IN THE DRAWINGS

REMARKS

Amendments to the Drawings

FIG. 3

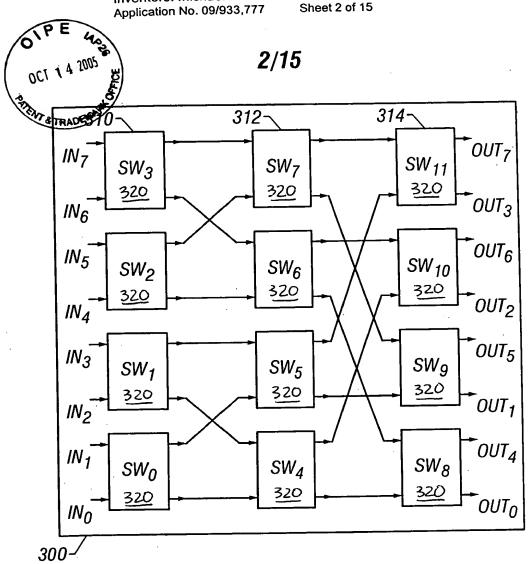
Please replace Drawing Sheet 2, including Fig. 3 and Fig. 4, with the attached Replacement Sheet, including amended Fig. 3 and original Fig. 4.

For the Examiner's convenience, changes made to Fig. 3 and to Fig. 5 are noted in red in the attached Annotated Sheets.

Applicant has amended Fig. 3 to identify each switching cell with a reference numeral 320. This amendment is supported by the specification in the paragraph beginning on page 3, line 12. Applicant has amended Fig. 5 to identify the first signal propagation path with a bracket and a reference numeral 580 and to identify the second signal propagation path with a bracket and a reference numeral 582. This amendment is supported, for example, by the paragraph beginning on page 9, line 21. Applicant submits that no new matter is introduced as a result of these amendments.
